PORTLAND PUBLIC ART COMMITTEE

Wednesday, December 16, 2020
4:00 p.m. – 6:00 p.m. Online via Zoom

DEERING CORNER ROUNDABOUT
Stone Bench Sketch - Review with
Artist
11/19/20
Sebago Technics, Inc.

Original Bench Concept:

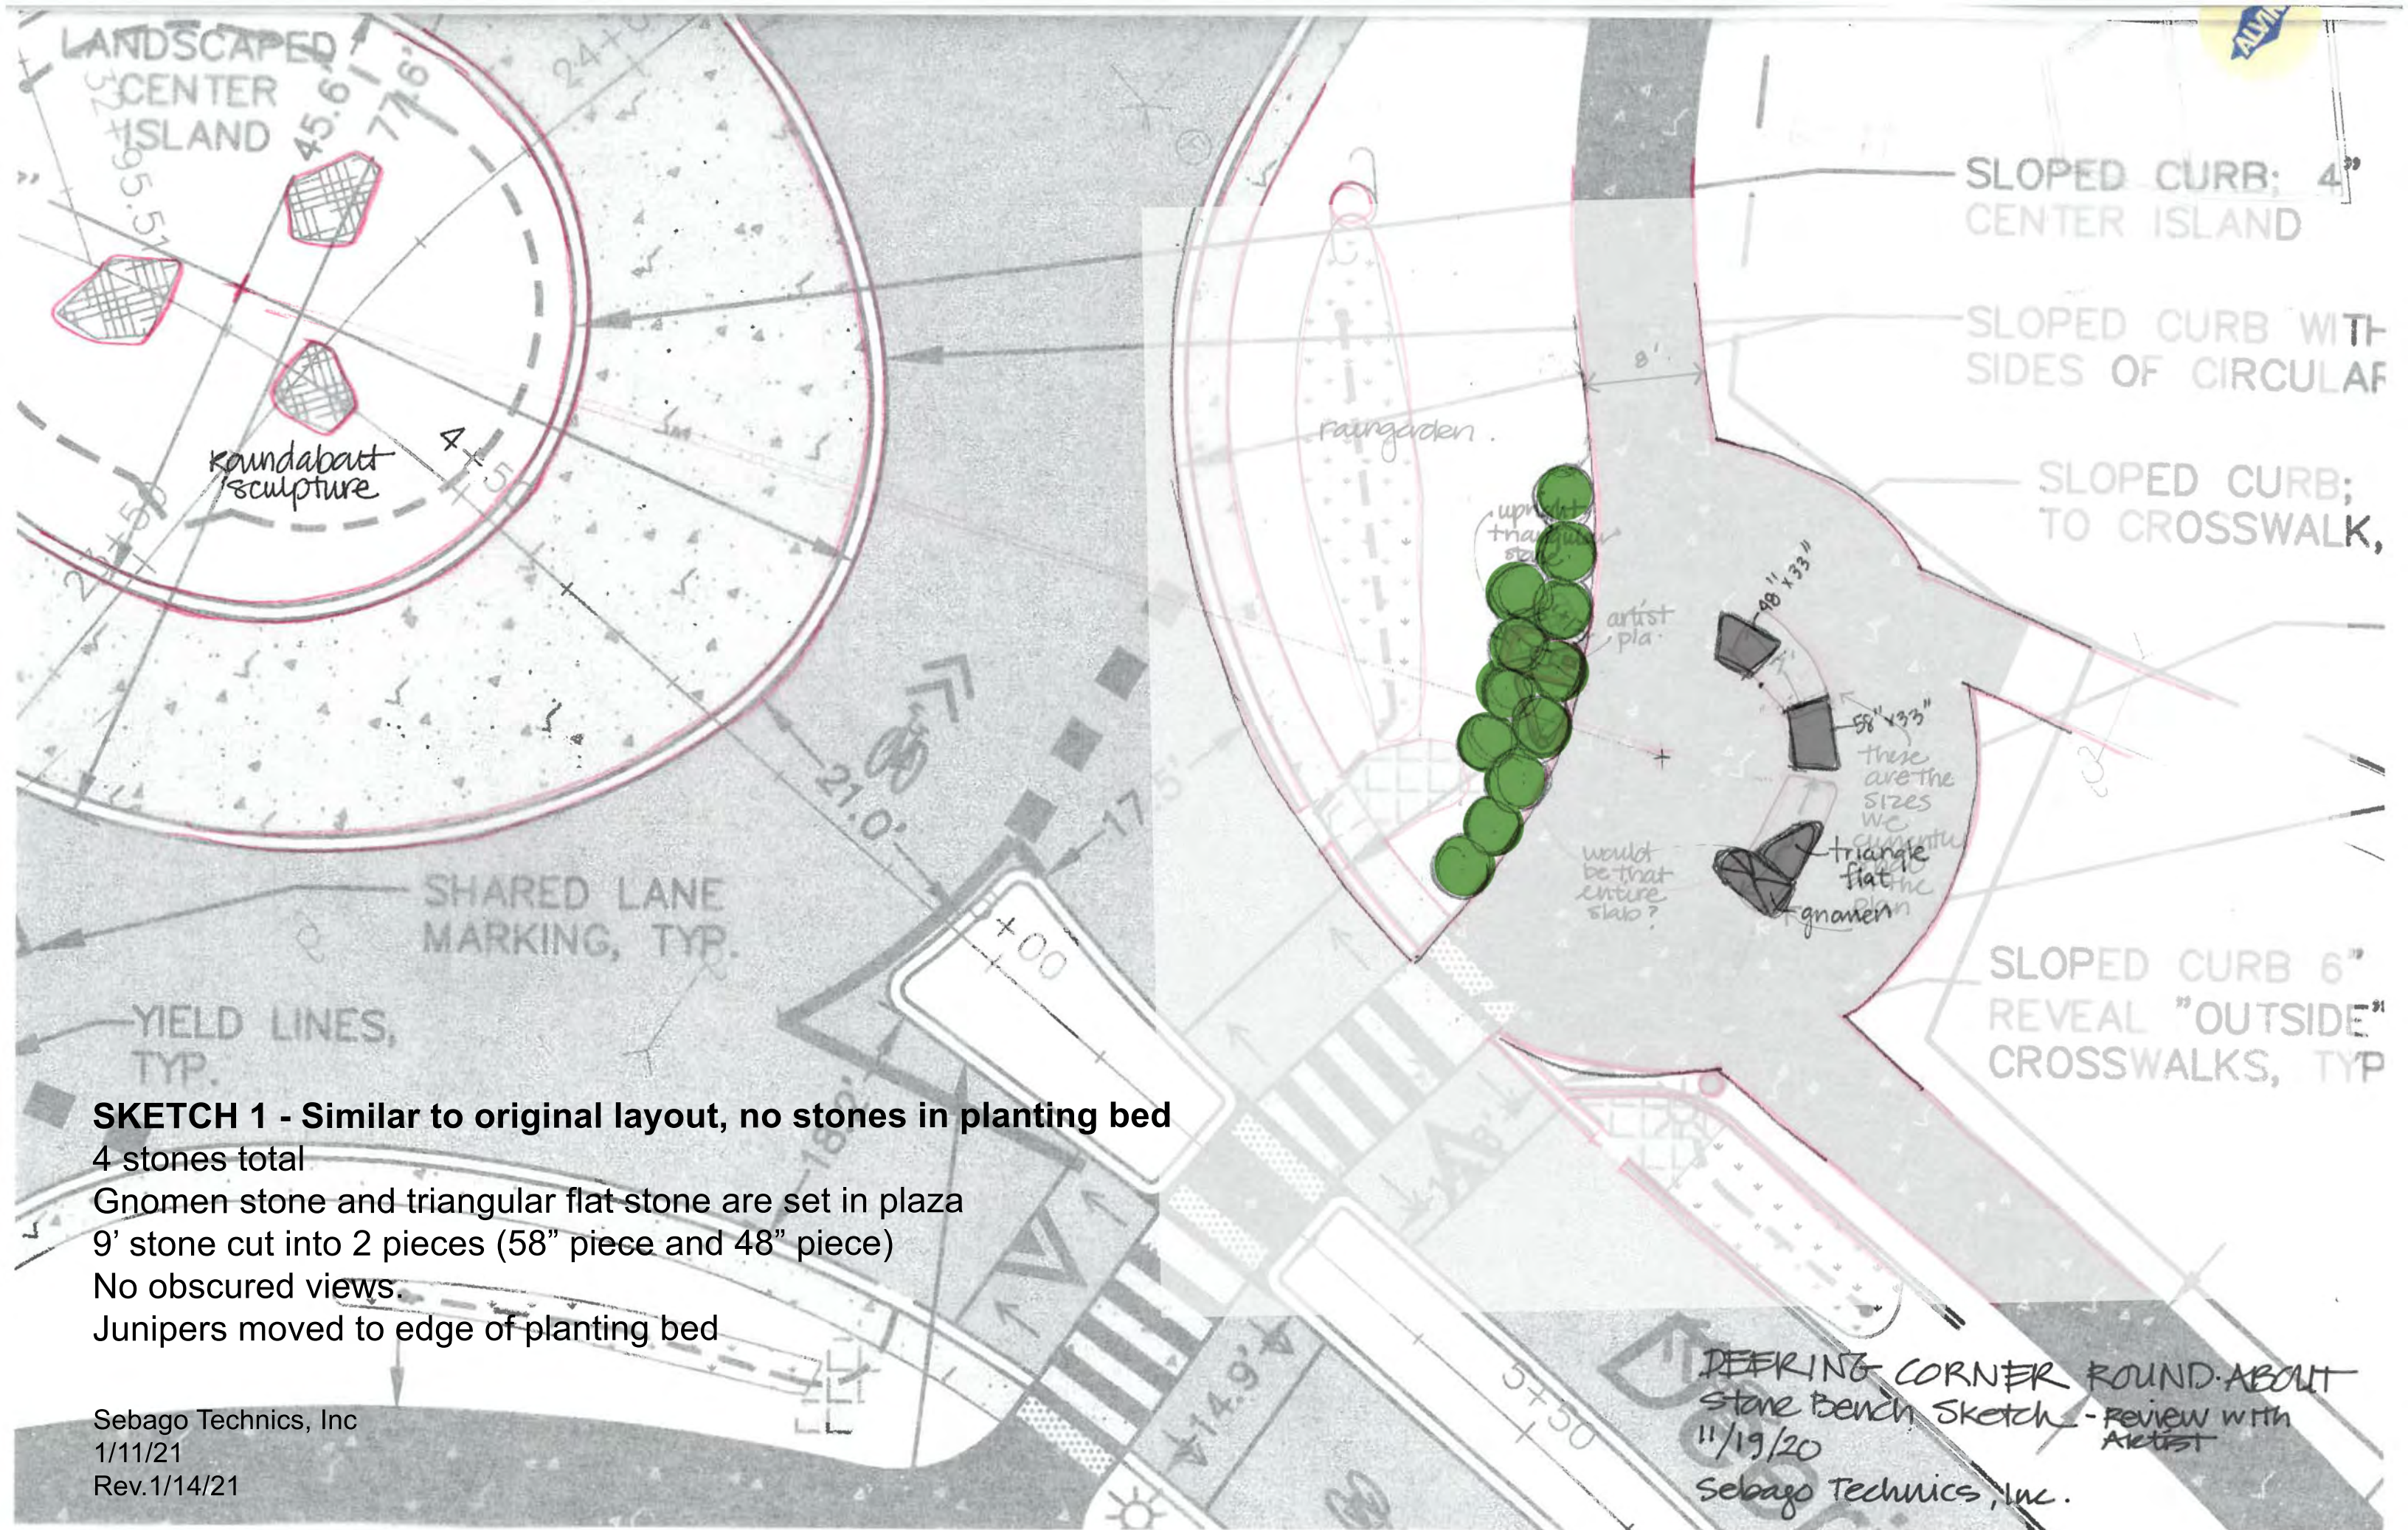
Landscape Design changes:

- Sidewalk layout revised to move away from roundabout
- Sidewalk plaza reduced in size
= less area for bench stones

- 3 stone benches cut from same stone
- Formed in semi-circle facing roundabout
- Taller stone “chaise” to mount plaque

Description of proposed changes:

- 1) Shift gnomon stone into landscape area, plaque mounted to be read standing in plaza facing artwork, and additional triangular stone is next to it
- 2) Reduce the size/number of bench stones either
- 3) Select the placement of the stones

Cost: Depending on our final selection of the layout the quarry is asking for an additional \$1500 to \$2000.

SKETCH 2 - Similar to current layout

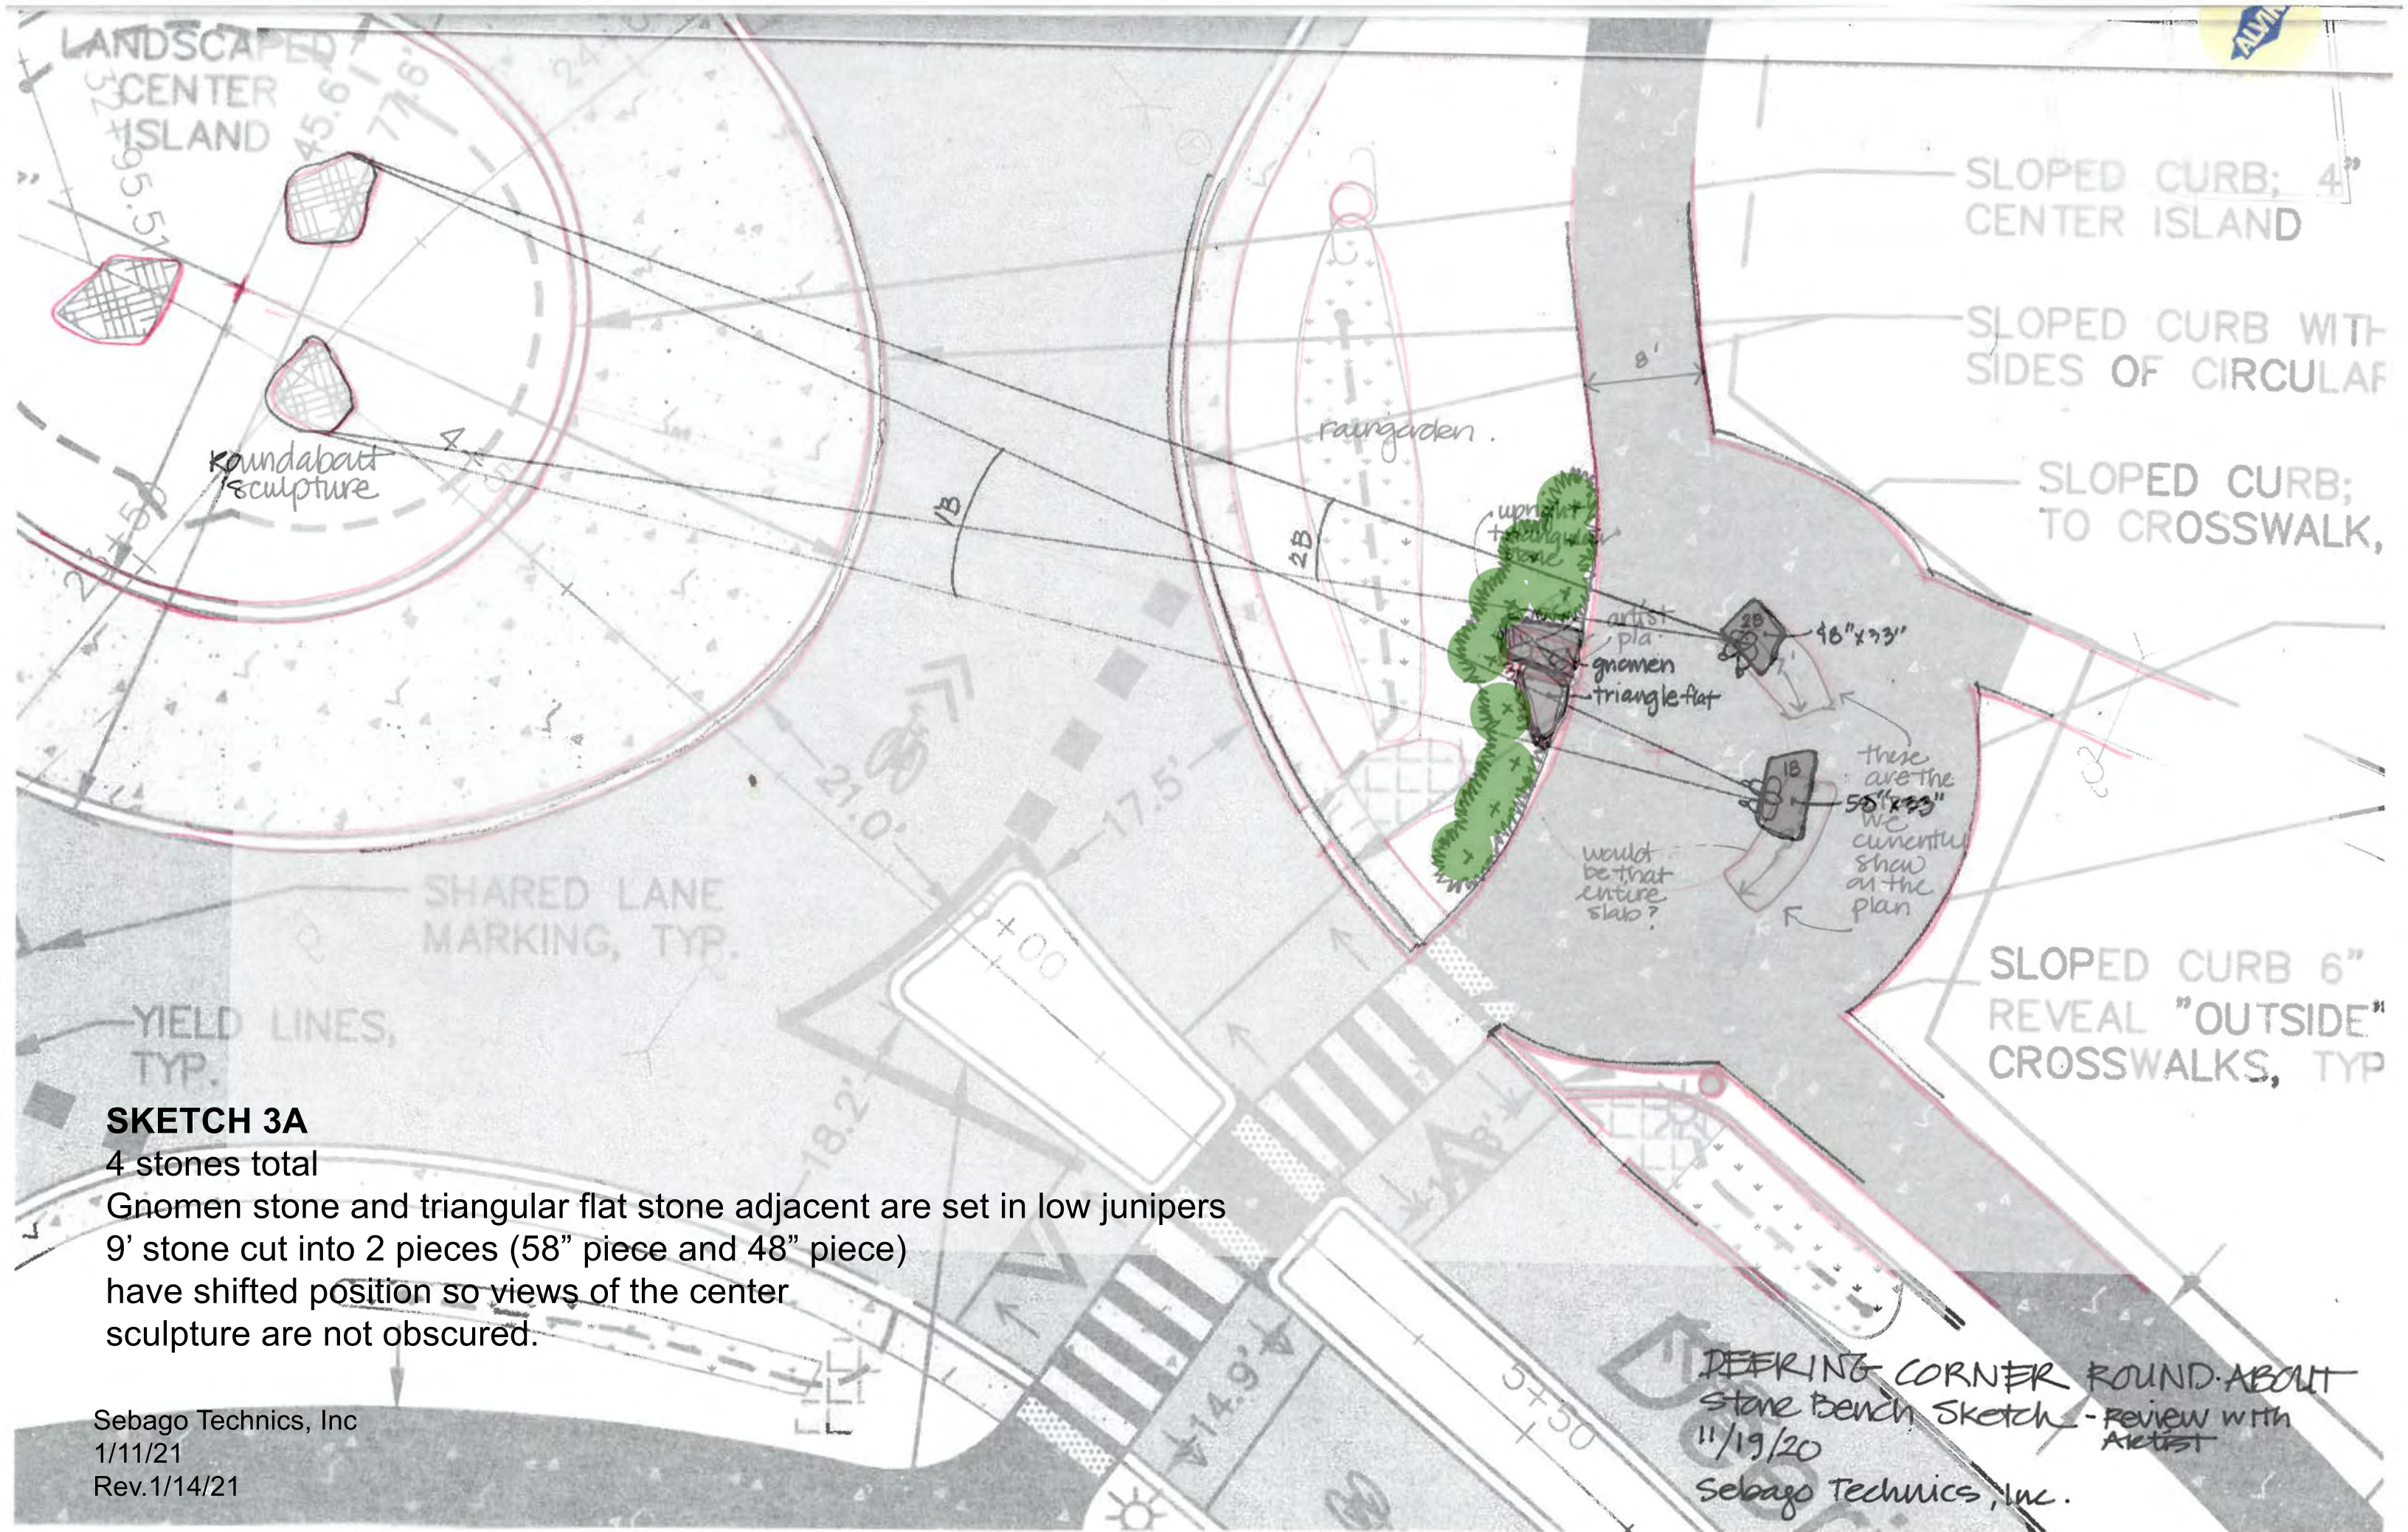
- 4 stones total
- Gnomon stone and triangular flat stone are set in plaza
- 9' stone cut into 2 pieces (58" piece and 48" piece)
- No obscured views.
- Junipers moved to edge of planting bed

4 stones total

Gnomen stone and triangular flat stone are set in plaza

9' stone cut into 2 pieces (58" piece and 48" piece) with smaller stone set into planting bed

No obscured views.

SKETCH 3A

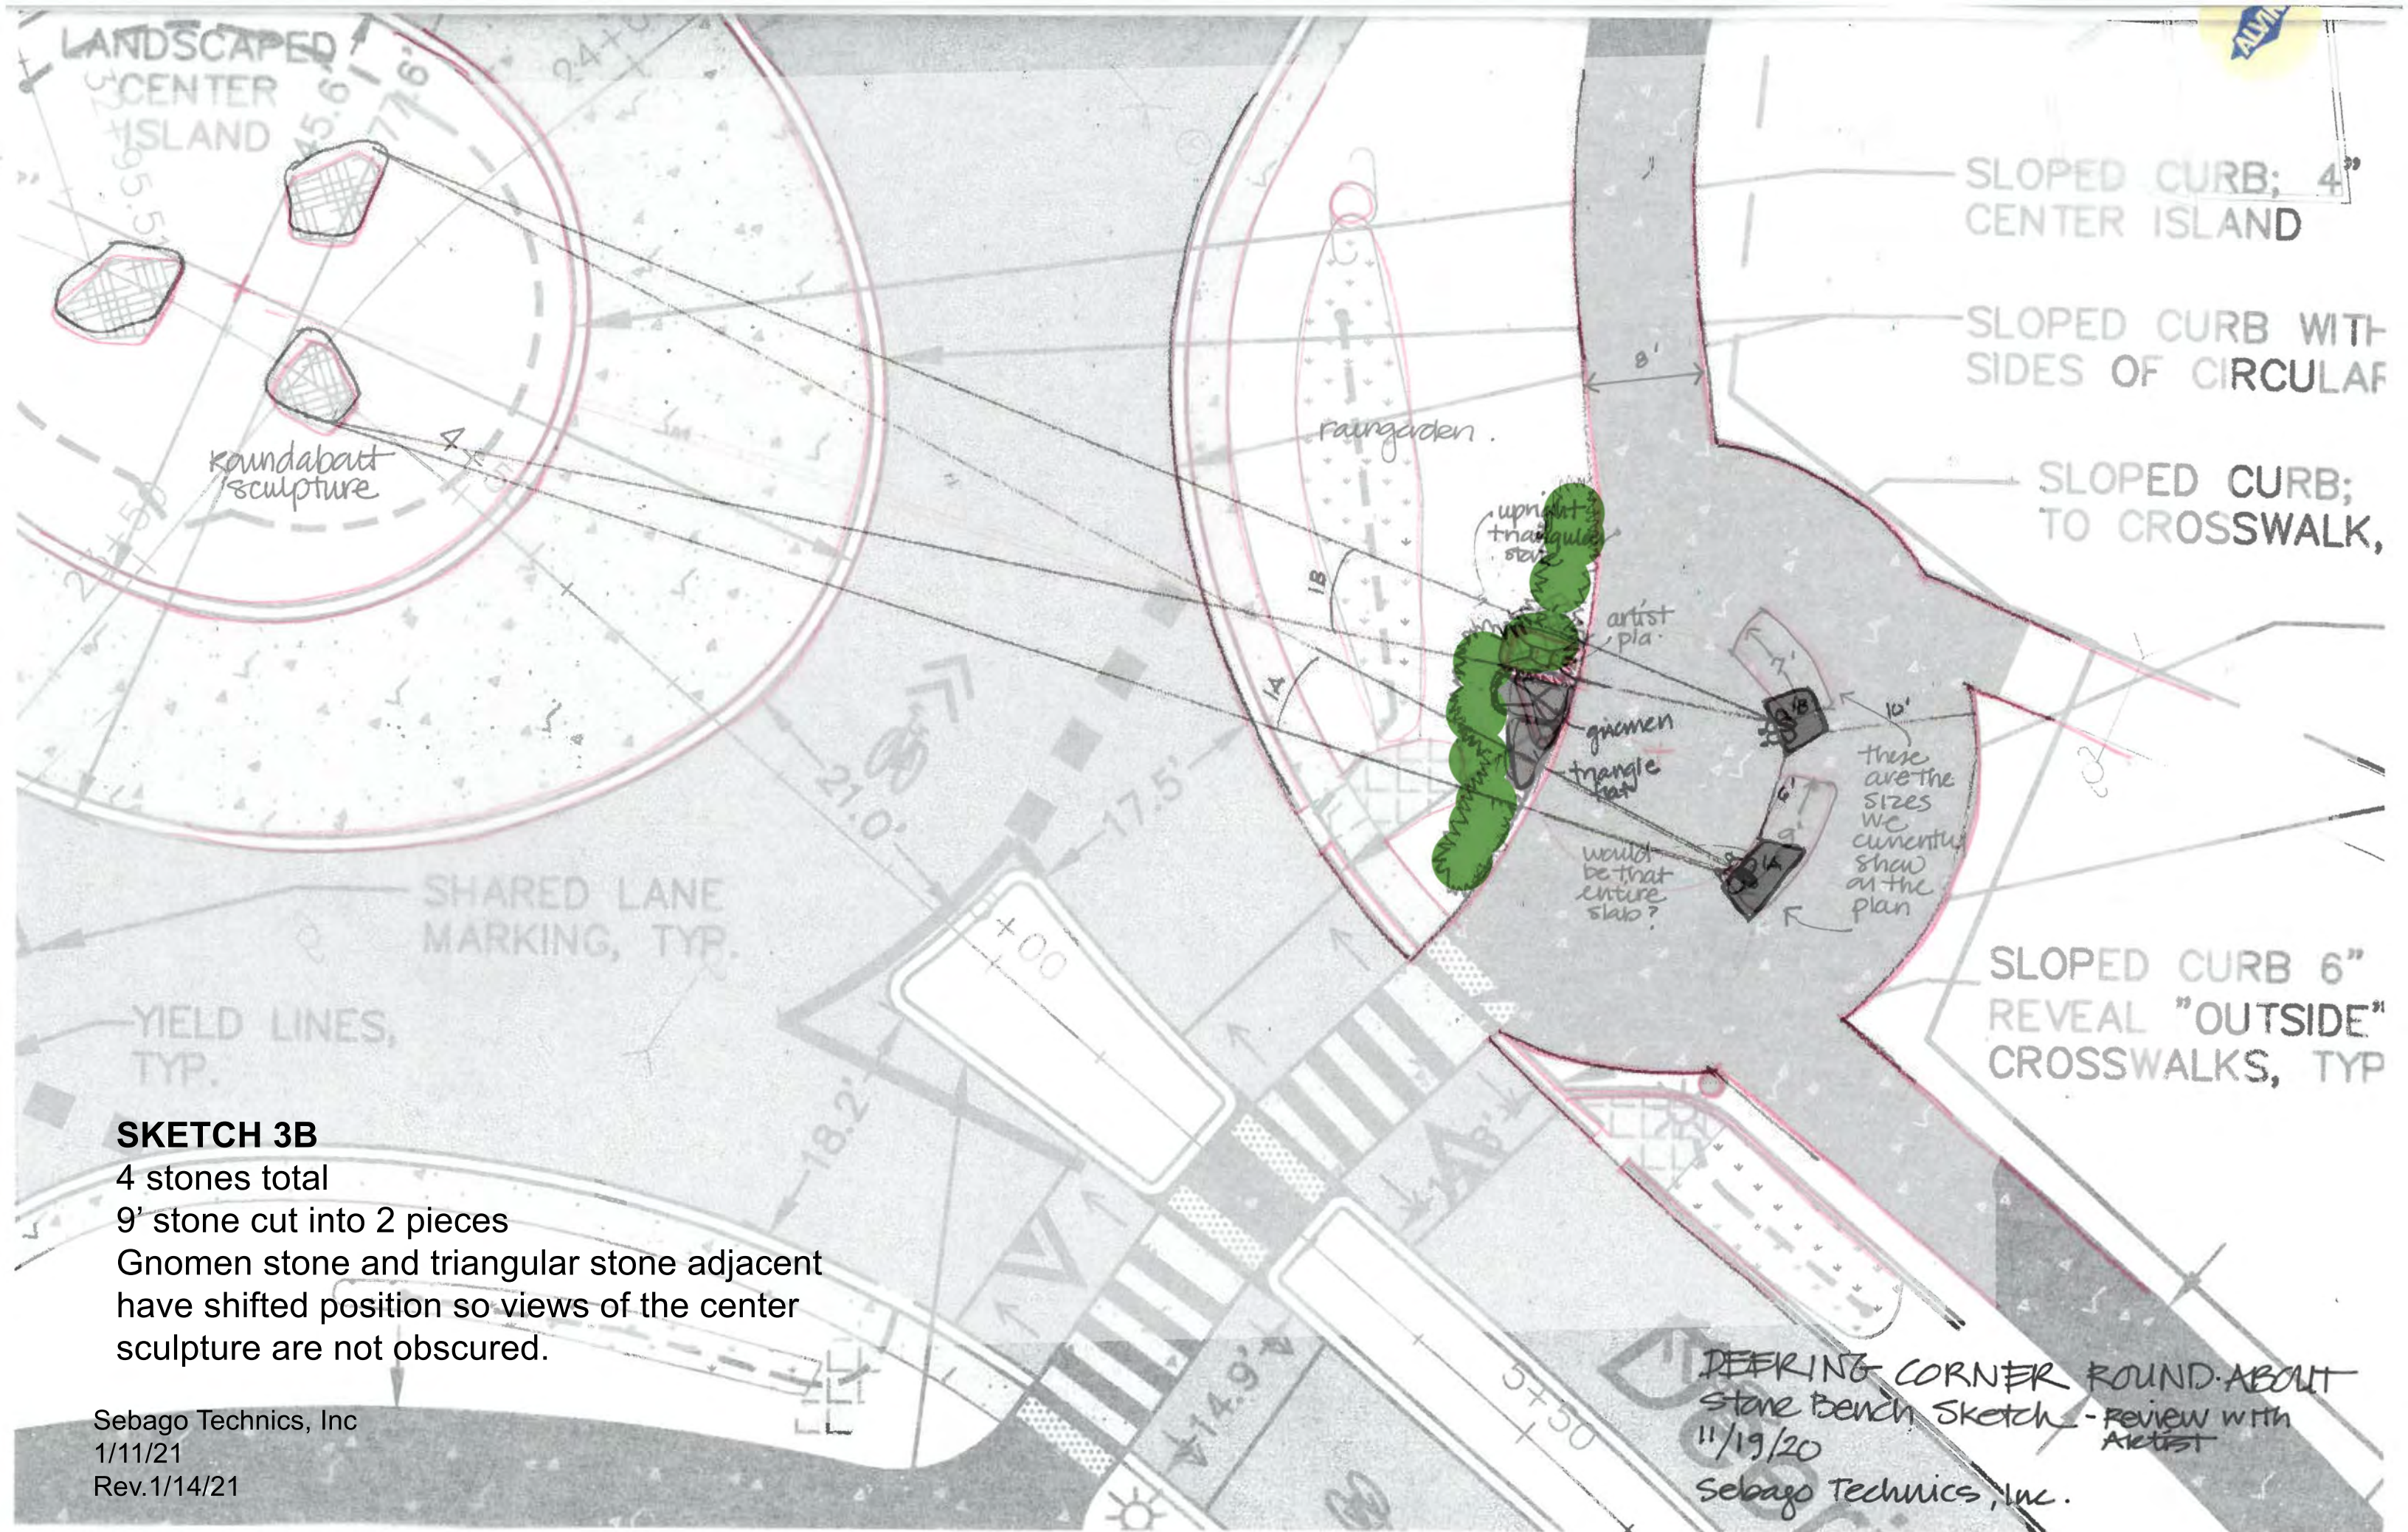
4 stones total
Gnomen stone and triangular flat stone adjacent are set in low junipers
9' stone cut into 2 pieces (58" piece and 48" piece)
have shifted position so views of the center sculpture are not obscured.
